MEMORANDUM

Reference: Planning Commission May 12, 2022

We have reviewed the application for 2325 Milton Road for Planning Commission Meeting on May 12, 2022, and we recommend approval by the Commission.

TO: Mayor Brennan and Members of City Council
FROM: Kelly M. Thomas, Clerk of Council
DATE: May 13, 2022
RE: Planning Commission Decision

PRELIMINARY SITE PLAN
FOR THE
KAZEN RESIDENCE
2325 MILTON ROAD
UNIVERSITY HEIGHTS, OHIO
3/28/2022
DESIGNED BY
JOSEPH E. CALDERWOOD, DESIGNER
440-429-5164

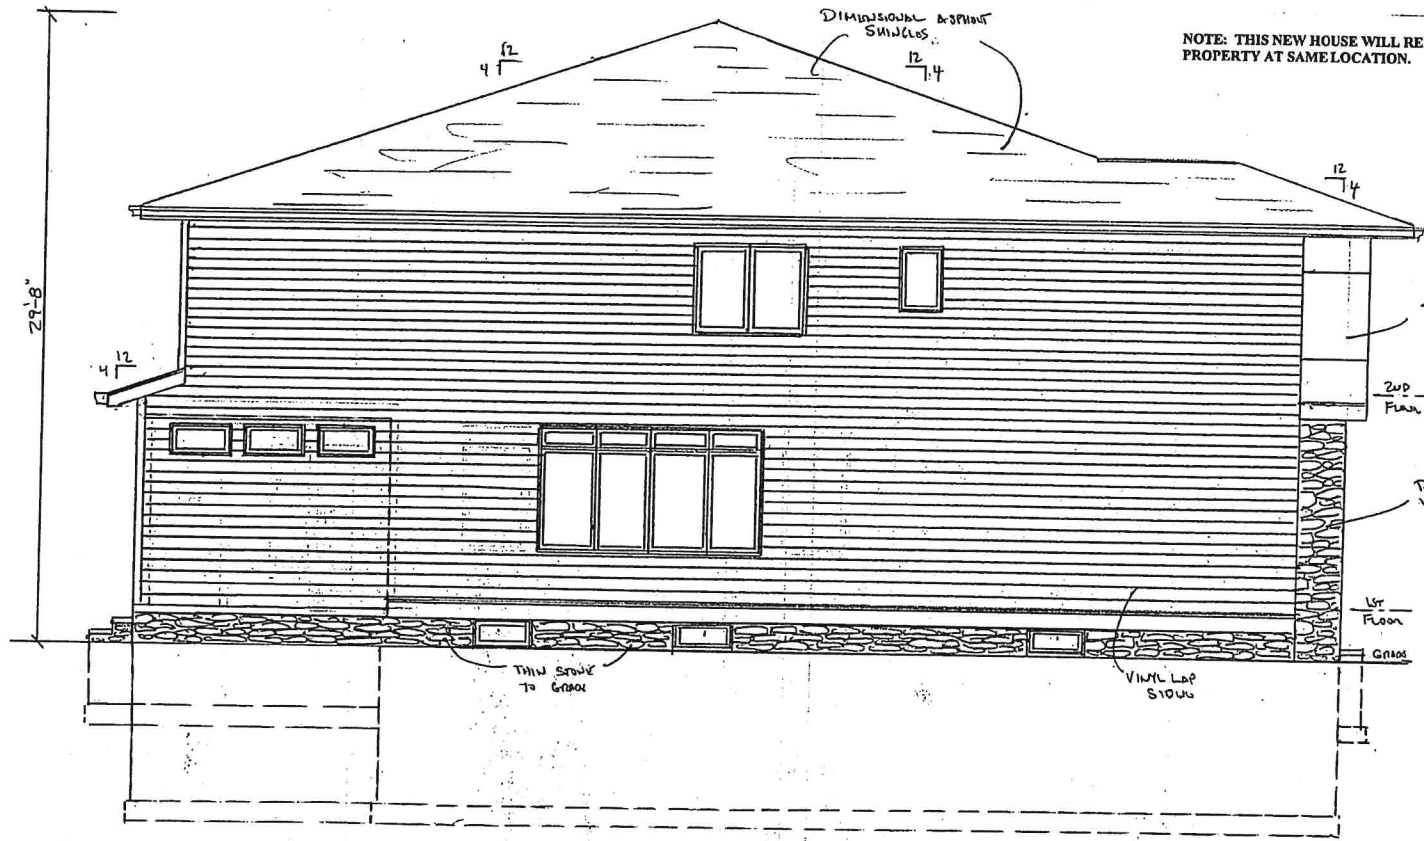
1. The applicant must submit a house topo site plan prepared by an Ohio Registered Surveyor showing the footprint of the house, the setbacks, the grades, the utility connections and the Storm Water Pollution Protection for erosion control during construction.
2. Cleveland Water Dept. must review and approve the water connection to the new home.

Mr. Rach also requested that the applicant brings with them pictures showing all four sides of the existing house, site plan showing the existing footprint of the home and with the proposed new home over top of that in order to make sure that the new house fits within the context of the neighborhood and that it has a similar footprint of the house being demolished.

FIRST FLOOR PLAN:
 SCALE: 1/8" = 1'-0"
 1ST FLOOR AREA: 1,580 SQ.FT.
 GARAGE AREA: 462 SQ.FT.
 FRONT PORCH AREA: 83 SQ.FT.
 SIDE PORCH AREA: 7 SQ.FT.
 REAR COVERED PORCH AREA: 176 SQ.FT.

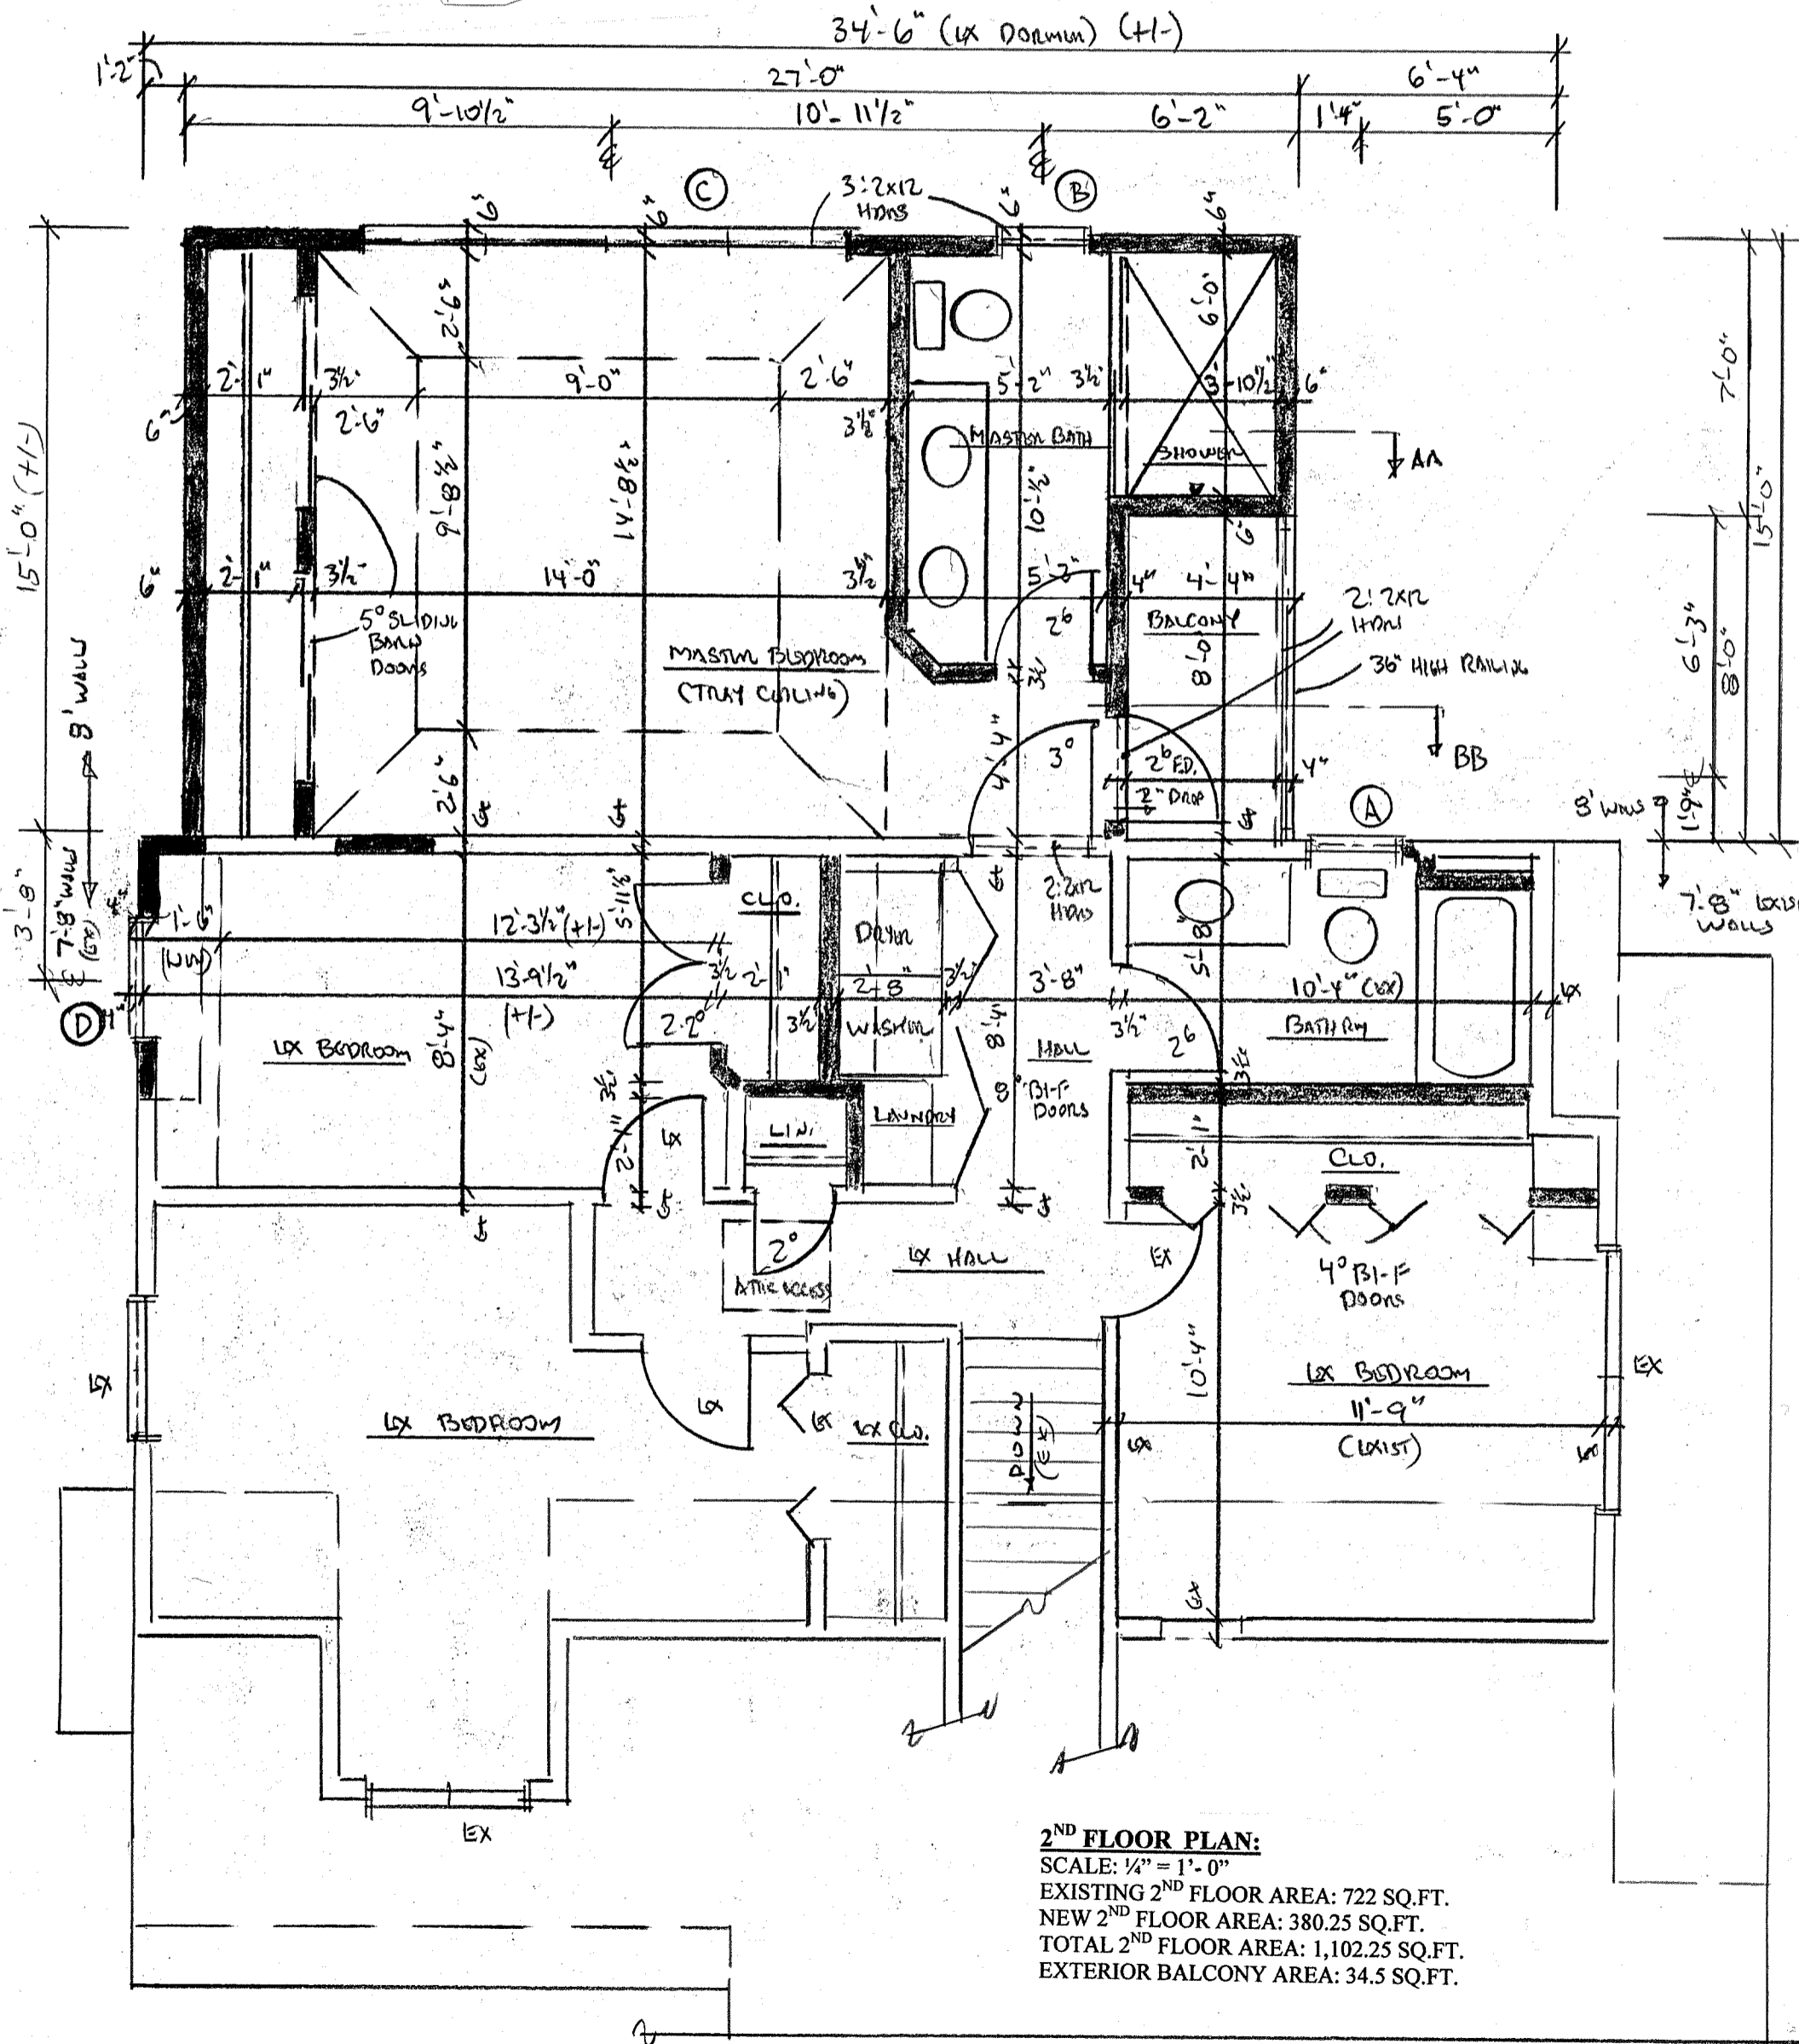
Mr. Rach noted that the plans show an additional kitchen on the lower level and that it would require a Variance.

MOTION BY MR. RACH, SECONDED BY MAYOR BRENNAN that the Planning Commission Recommendation is further contingent upon the approval of a Variance by the Board of Zoning Appeals for a second kitchen on the lower level. On roll call, all voted “aye.”
